UNITED STATES
NUCLEAR REGULATORY COMMISSION
WASHINGTON, D. C. 20555

Docket No. 50-271

RE: ACCEPTANCE CRITERIA FOR THE MARK I CONTAINMENT LONG TERM PROGRAM

NRC ACCEPTANCE CRITERIA
FOR THE
MARK I CONTAINMENT
LONG TERM PROGRAM

Figure 2.10-2 Impact and Steady Drag Force Correlation for Type 1 Deflector

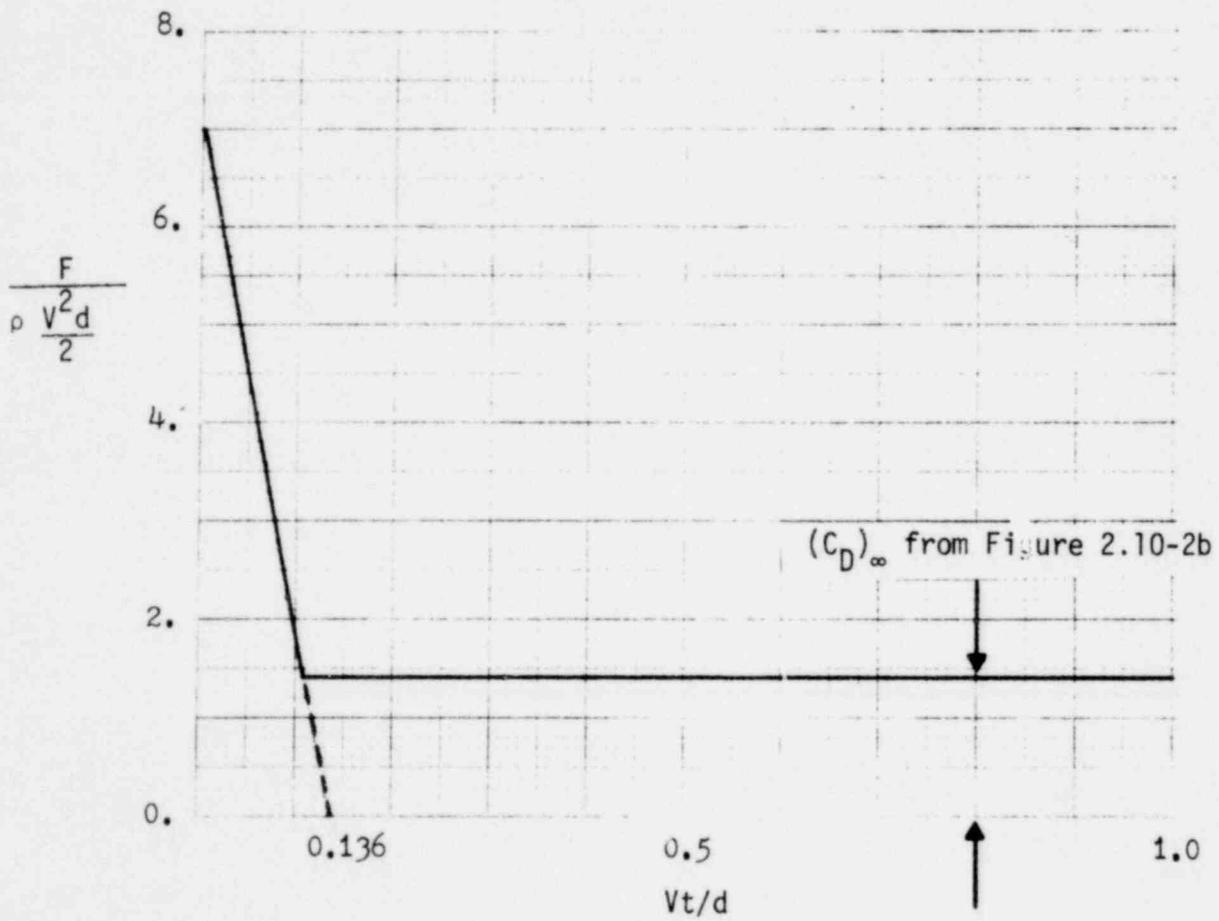
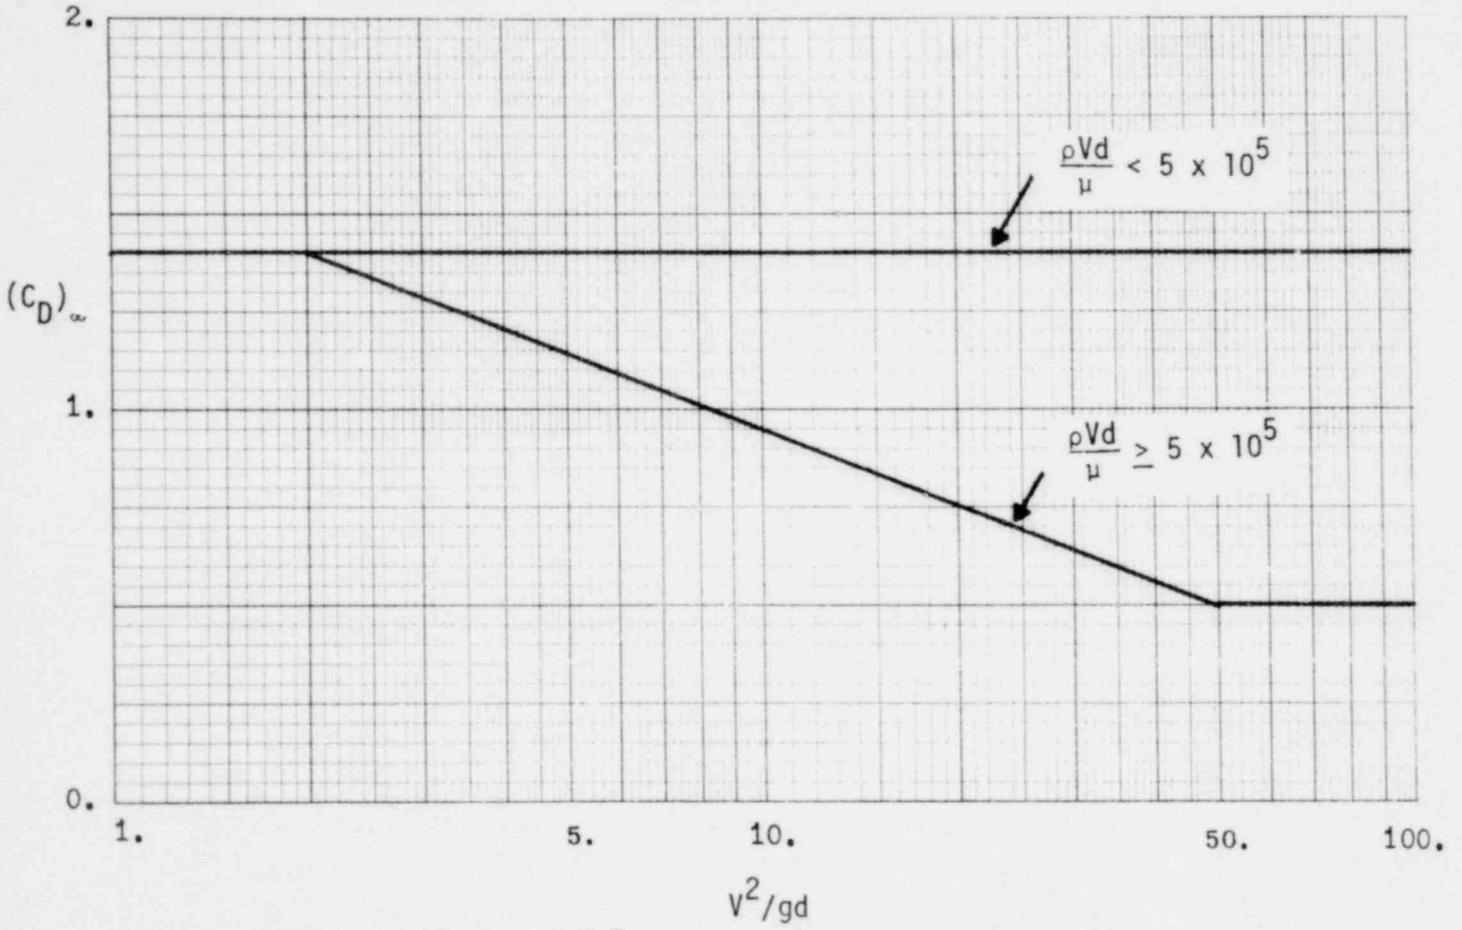
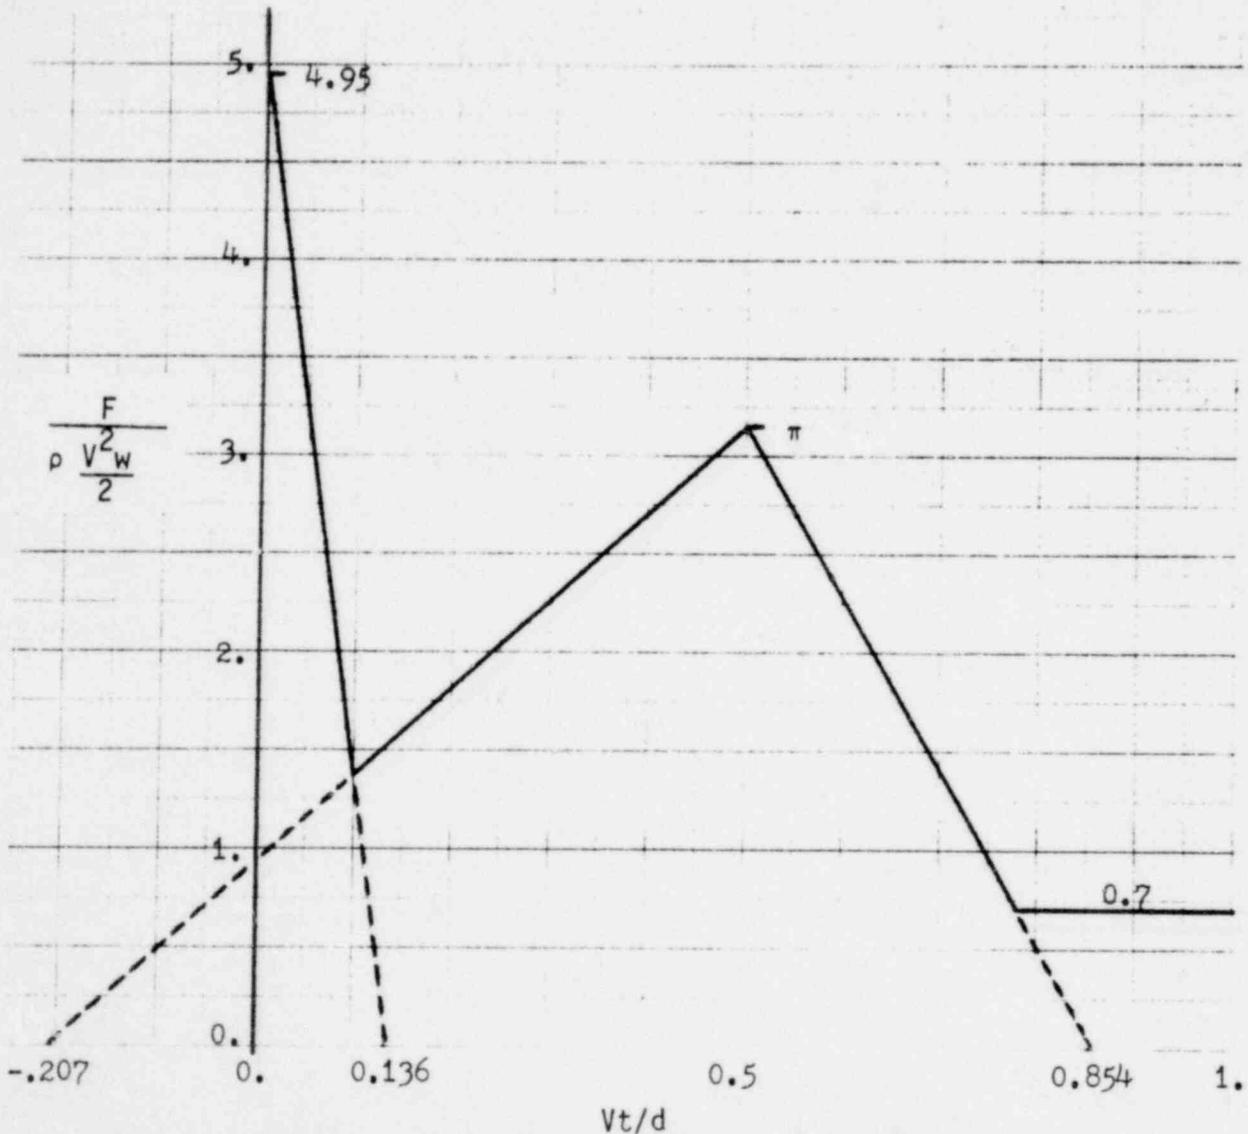
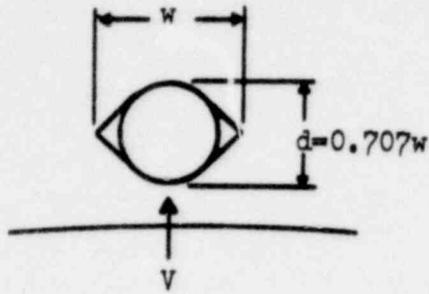
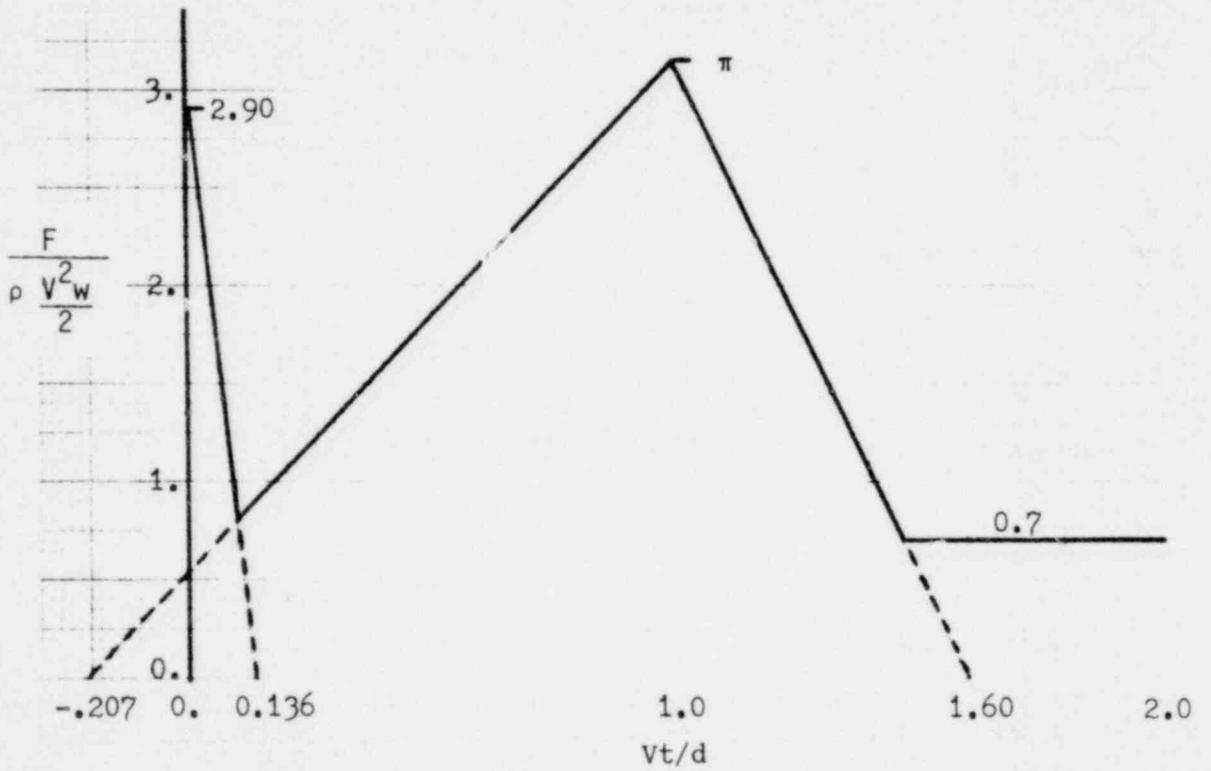
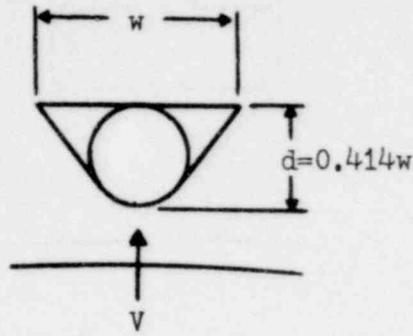
1. The impact transient and "steady drag" contributions to the load shall be computed from the correlations shown on Figures 2.10-2 through 2.10-5, for deflector types 1 - 4, respectively. For times past the periods shown, the last value shall be extended for the duration of the transient.
2. The three-dimensional load variation and timing shall be based on the EPRI "main vent orifice" tests, as discussed in Section 2.5.
3. The gravitational component of the acceleration drag shall be included in F_A , as defined in NEDO-24612.
4. In computing the deflector response to the load, the added mass of the water shall be accounted for, as described in Section 2.10.1.3 above.
